RE: Comments of Turner Ranch Properties, L.P. on the Draft Environmental Impact Statement for the Copper Flat Copper Mine

**COMMENTS ON THE DRAFT ENVIRONMENTAL IMPACT STATEMENT FOR THE
COPPER FLAT COPPER MINE**

**PREPARED BY THE NEW MEXICO ENVIRONMENTAL LAW CENTER (“NMELC”)
ON BEHALF OF TURNER RANCH PROPERTIES, L.P. (“TRP”)**

Figure 1: Outline of Ladder Ranch property lines with the Copper Flat Mine and production wells (PWs). Turn Ranch Properties, L.P. developed the base map for this figure.

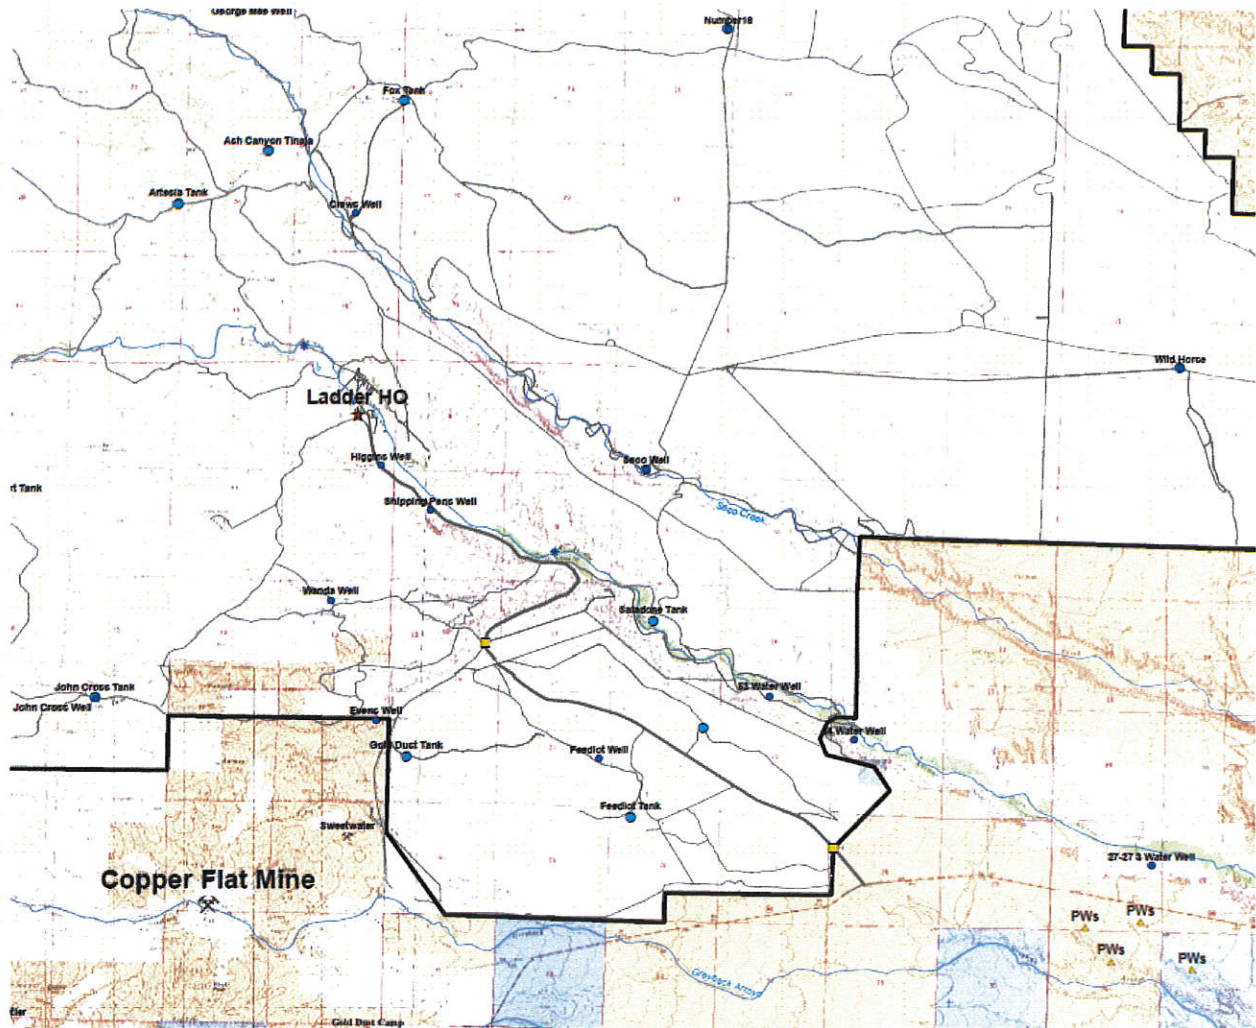
The DEIS model predicts that the one-foot drawdown under Las Animas Creek would extend about three miles beyond Ladder's southern boundary to about the Saladone Tank area (Figure 1). Drawdown under Las Animas Creek would be about 10 feet at Ladder's southern property boundary. This is an

Figure 2: DEIS Figure 3-15a showing a hydrograph of flow loss rates for the proposed action. Similar hydrographs to Figure 2 are shown in the DEIS for all alternatives.

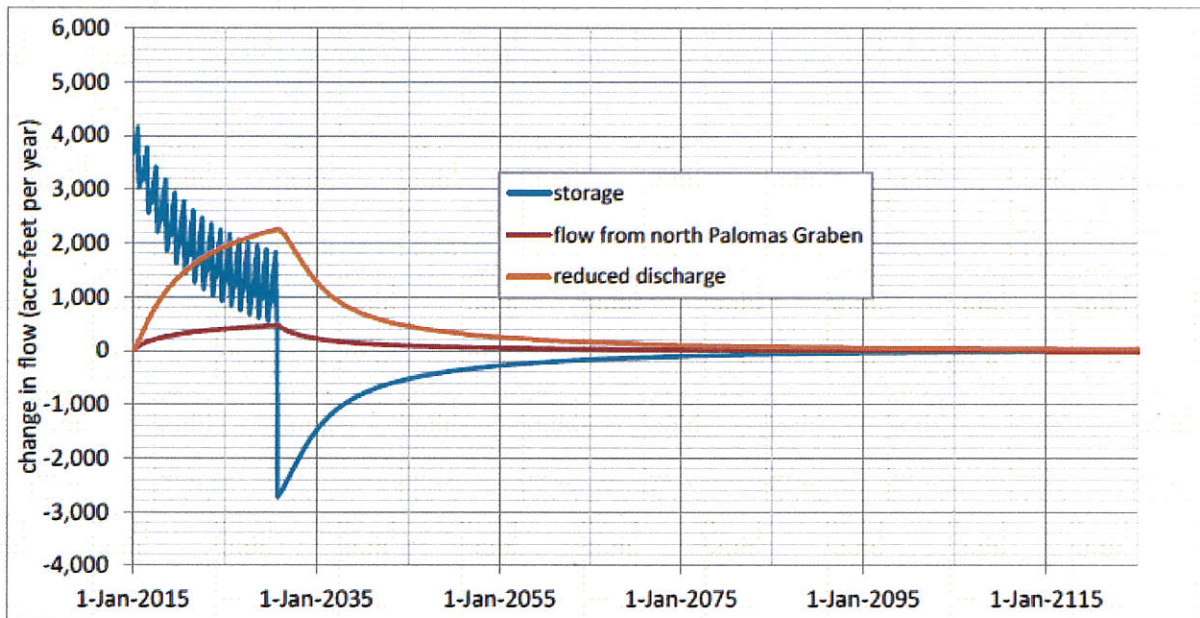
The maximum loss for all action alternatives rates (Figure 2) are about 0.2 to 0.3% of the total average flow from Caballo Reservoir. During drought, groundwater discharges to the river are the most consistent source of inflows to the reach because the valley aquifers are essentially additional storage for the river (Bureau of Reclamation 2013). For this reason losses to groundwater discharge will be much more important during drought periods. There have been years during which the average flow from the reservoir was about a quarter of the long-term average, so the reductions due to lost groundwater inflow can be as much as 1% of the total river flow at the Caballo Reservoir.

The modeling also allows groundwater to enter from the north into the graben (Figure 2). For example, up to 665 af/y was induced to enter the graben for Alternative 2 (Table 1). However, as discussed above, the DEIS does not disclose the source of this water from the north; the groundwater model simply models it as a boundary with unlimited available water without explaining its source (Jones et al. 2014). This additional flow to the graben prevents additional groundwater from being removed from groundwater storage, which would cause additional drawdown. This unreasonable assumption also fails to account for groundwater that would not be discharged to surface water, which would in turn prevent accounting for further decrease in flows to the Rio Grande.

Figure 3: DEIS Figure 3-13b showing drawdown in model layer 2 at the end of mining for the Proposed Action.

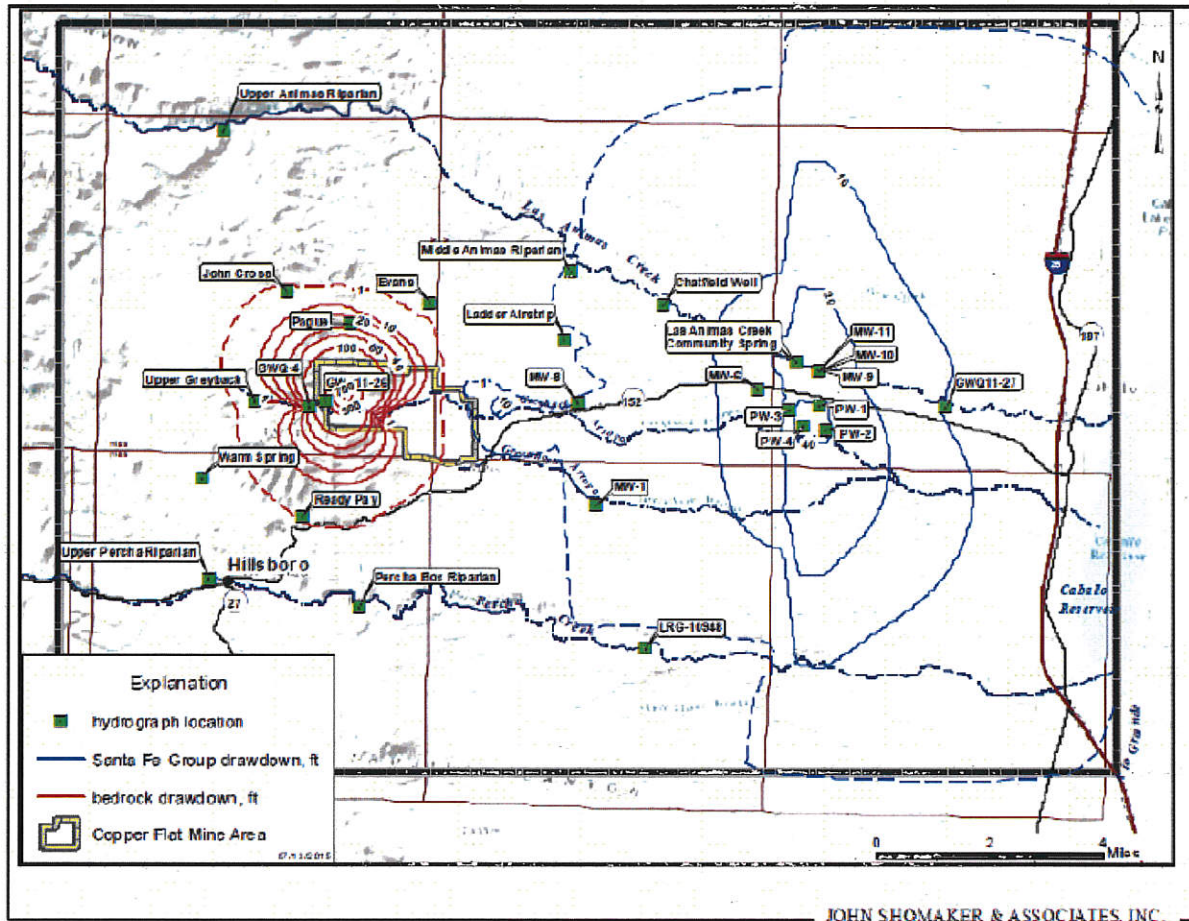
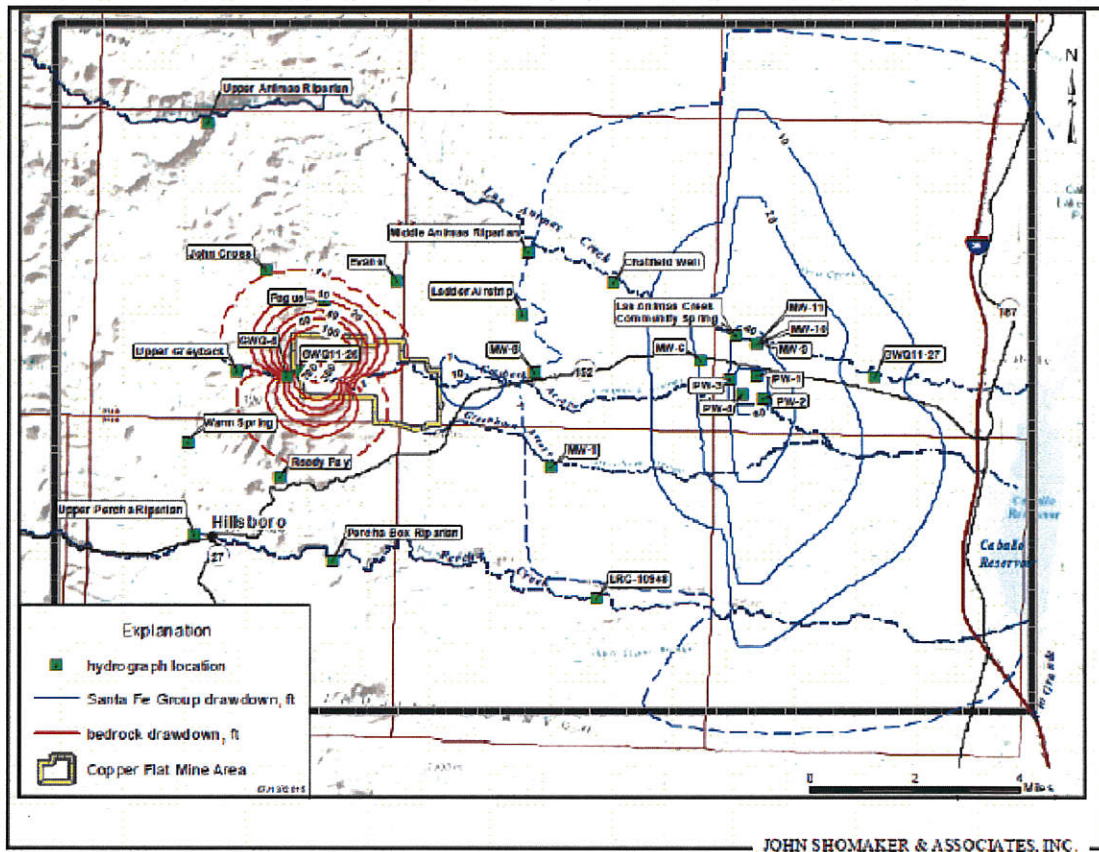
The drawdown cone caused by the Mine's production well pumping (Figures 3 and 4 show DEIS Figure 3-13b and 3-15b for the Proposed Action and Alternative 2, the Preferred Alternative, respectively) shows minimal drawdown at Caballo Reservoir; the dashed contour intersects the reservoir. The reservoir prevents the groundwater from drawing down at the reservoir because the reservoir adds water to the groundwater model domain. The groundwater model uses a boundary for the reservoir which, in the modeling, sets the water level. Drawdown affects the reservoir by diverting groundwater flow from

Figures 3 and 4 show that drawdown contours are elongated north-south parallel to the reservoir. This is due to biases coded into the modeling, as discussed in detail in the conceptual model and numerical modeling sections below. The biases are due to how the models establish the properties of the Palomas Graben, the geologic feature in which the Mine's production wells are located. The models assume the Palomas Graben is a north-south trending feature with transmissivity much higher than the surrounding aquifer, a conceptualization not supported by data. The models also assume that faults bound the graben on the east and the west, with the fault on the west being almost impervious.

The drawdown cone at the Mine pit (Figure 3) is much deeper than that at the production wells for all action alternatives (Figures 3 and 4), but represents much less water removed from storage due to the much lower porosity in the bedrock around the pit. After mining, a small pit lake will form and evaporate water in perpetuity. This evaporation will cause the pit to hydraulically resemble a large diameter well in perpetuity. The DEIS discloses the evaporation rate for the Proposed Action will be about 100 af/y (DEIS p 3-76), but does not disclose the evaporation rate for Alternative 2, which will be larger because the pit is larger. Pit lake evaporation is a permanent loss of flow to the Rio Grande, although it will not manifest at the river for a very long time due to travel time between the pit and river.

Figure 9: Figure 8-14 from INTERA (2012) showing actual 2011 groundwater contours.

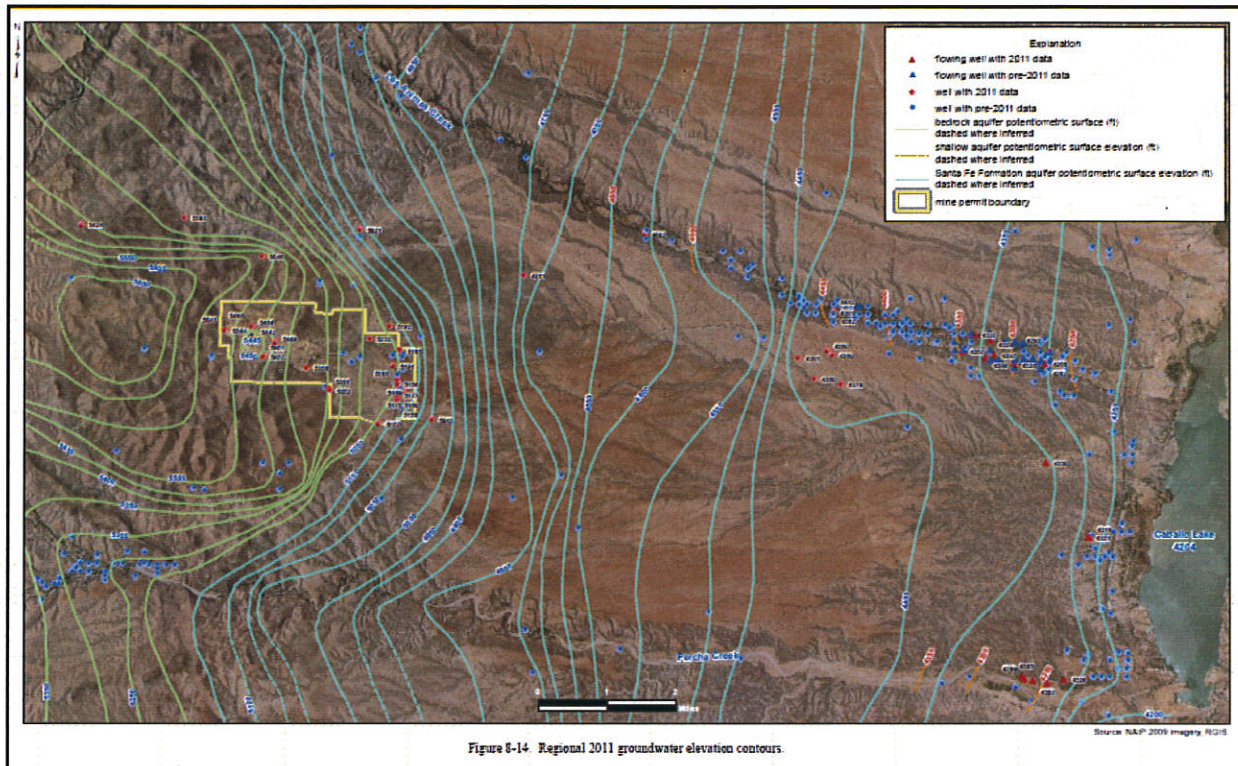
Groundwater Contours: The groundwater contour map, INTERA Figure 8-14 (reproduced as Figure 9 herein) shows a west to east gradient through the study area, with contours affected by topography, aquifer permeability, and the elevation of discharge points (such as the river and creeks). Low permeability in the Animas uplift generally, and the andesite around the Mine, diverts groundwater flow from the west around the pit area north and south to Las Animas Creek and Percha Creek, as indicated by the mounding (Figure 9). INTERA suggests that the groundwater mound shows how the andesite diverts groundwater into the creeks. There are springs in the upper part of Las Animas Creek that could result from flow diverted northward, but the springs could also result from local recharge in the graben (the area of which INTERA Figure 8-12 indicates is much larger in the Las Animas watershed). Understanding these flow paths is essential to modeling and predicting the effects of the Mine, but INTERA falls far short of supporting its hypothesis.

The groundwater contour map (Figure 9) shows a substantial west to east gradient through the andesite and Mine area that could reflect more groundwater flow than accounted for by INTERA (and the DEIS). If the analysis is wrong, there can be substantially more dewatering for the pit than estimated. Its effects on the drawdown cone will depend on aquifer properties. The DEIS simply does not have adequate hydrogeologic data to support its conclusions regarding the effects of dewatering. The wells are not deep enough to provide sufficient data concerning the properties at depth.

The groundwater contour map (Figure 9) also does not support other ideas presented by INTERA and assumed in the CFM:

- There is no evidence that faults are flow barriers. A flow barrier would cause a steplike shape in the contours, which is not present in Figure 9.
- The contours do not indicate flow from the north enters the study area domain, as INTERA (and Jones et al. 2012) suggest occurs.

Figure 11: Snapshot of a section of a portion of Figure 8-17 (INTERA 2012). The figure shows a section west-east through the existing tailings impoundment, including a sulfate plume emanating from the tails.

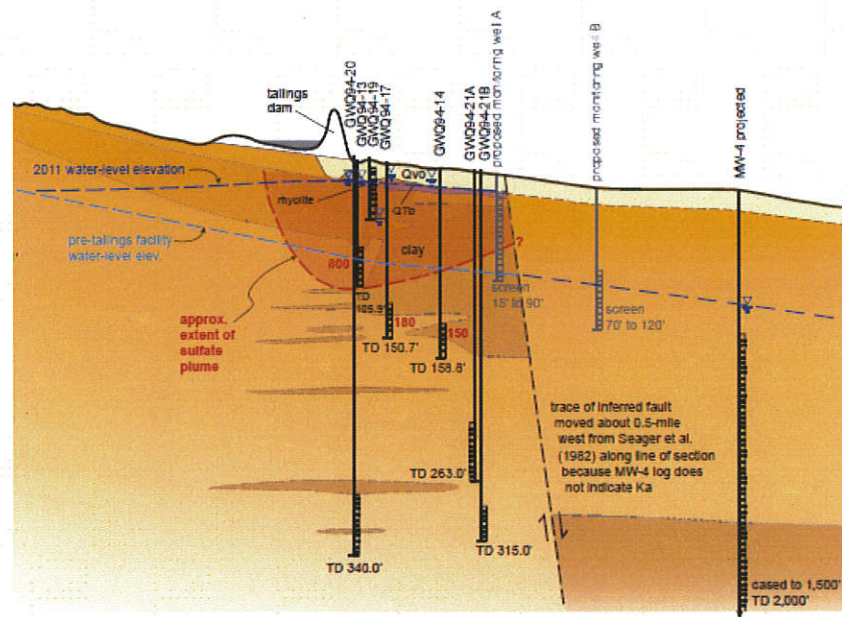
The cross-section figure also misrepresents the vertical extent of the plume. Wells GWQ94-21A and -21B are beneath the plume, but have sulfate concentrations at 120 mg/l. Even the deeper well GWQ94-20 has concentrations as high as 56 mg/l, although the last observation was in 1996. It should have been sampled during the baseline sampling period to estimate whether its concentration has increased. If the fault prevents or limits eastward flow and there is a mound under the tails, it is likely there is a downward gradient beneath the tails and west of the fault. A downward gradient would drive downward vertical flow so that contaminant advection and vertical dispersion could cause sulfate concentrations to increase at depth.

Figure 12: Portion of Figure 5, JSAI (2013), showing groundwater contour details near the existing tailings impoundment.

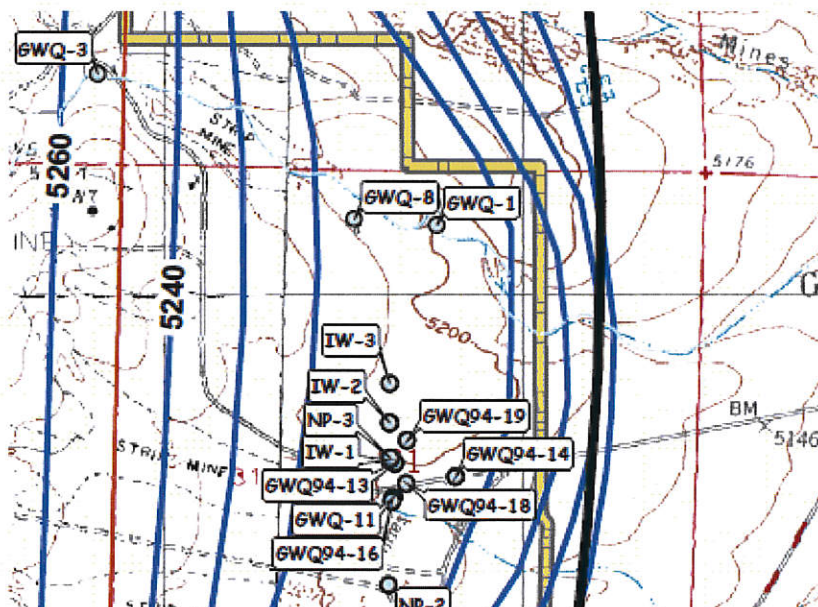
The contours in JSAI Figure 5 show crenulations that would exist if the groundwater elevation was higher and groundwater actually discharged into the alluvium, but there is no well data to support the placement of these crenulations. The alluvium of Grayback Arroyo could act as a hydraulic drain, but the referenced Figure 6 does not provide evidence in support of that. JSAI states that downgradient of GWQ-1 (east of it) the “hydraulic gradient steepens as a result of the barrier boundary effect of the East Animas Fault Trend.” *Id.* Figure 12 contained herein, is a snapshot of a portion of JSAI (2013) Figure 5, and shows the steepened contours between GWQ-1 and the fault, but fails to show monitoring wells to support the location of the contours. In fact, if the fault is a barrier, the groundwater table west of it will be flat due to a backwater effect, just as water ponds upstream of a dam. The steep gradient will occur as a change across the fault, not on one side of it.

Incidentally, the various reports have different locations for the East Animas Fault. JSAI (2013) shows the fault east of the east property boundary, whereas Jones et al. (2013) show the fault as much as half a mile further west, albeit as inferred (Figure 4.3, Jones et al. 2013); the same figure shows another fault just east of the property line in roughly the same location as the East Animas Fault in JSAI (2013). Discussion on JSAI (2013) page 18 suggests there is a difference of opinion regarding the exact location.

Figure 14: Figure 6.3 (Jones et al. 2014) showing layer 2 hydrogeologic zones.

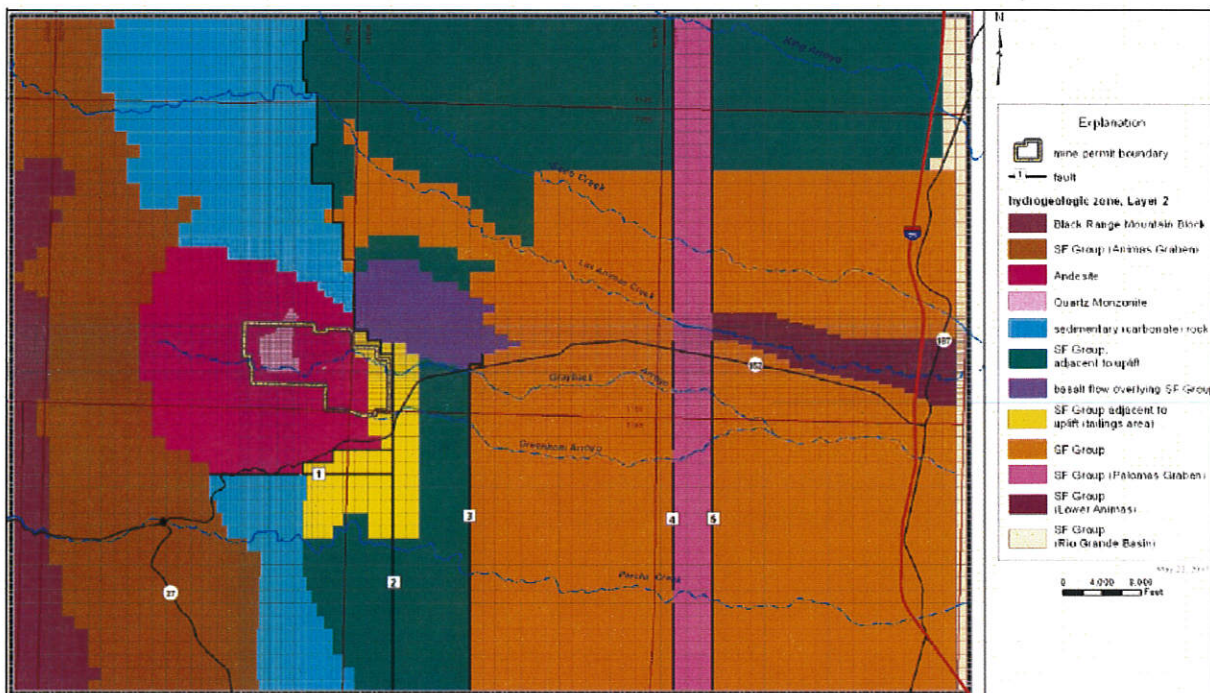
Figure 14, herein, also shows the location of faults simulated in the DEIS model; and Jones et al. Table 6.2 shows the conductivity values used to determine the conductance for the horizontal flow barrier ("HFB") model, which is used to simulate the faults. The groundwater contour maps suggest very strongly that the groundwater model simulates the faults as being far more effective as flow barriers than the data actually justifies.

drops that could be assigned to faults (Figure 14) that is at all similar to the simulated effect (Figure 16). The actual groundwater contours do not suggest the faults are barriers as conceptualized by Jones et al. (2013, 2012).

Figure 15: Screen capture of layer 2 from the Jones et al. model showing the plan view (below) and cross-section above. The figure is from the steady state model files.

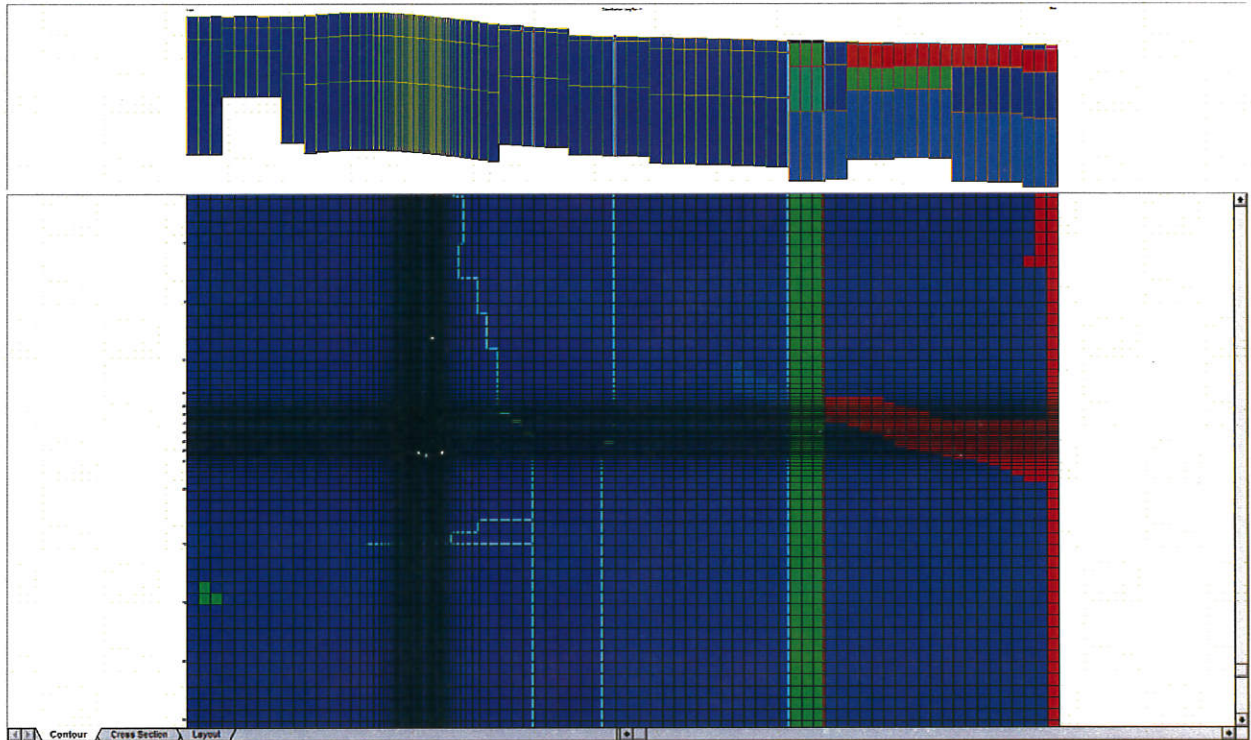
The variable thickness for layer 2 near the Palomas Graben is the most significant. At 10 ft/d (feet per day), the graben has one of the higher conductivity values for the Santa Fe group. Layer 2 thickness increases from 500 to 1,000 feet from west to east across the transition into the Palomas Graben (Figure 14). This causes the transmissivity to increase from 900 to 10,000 ft²/d⁵ from west to east across the transition. Production pumping occurs from the graben.
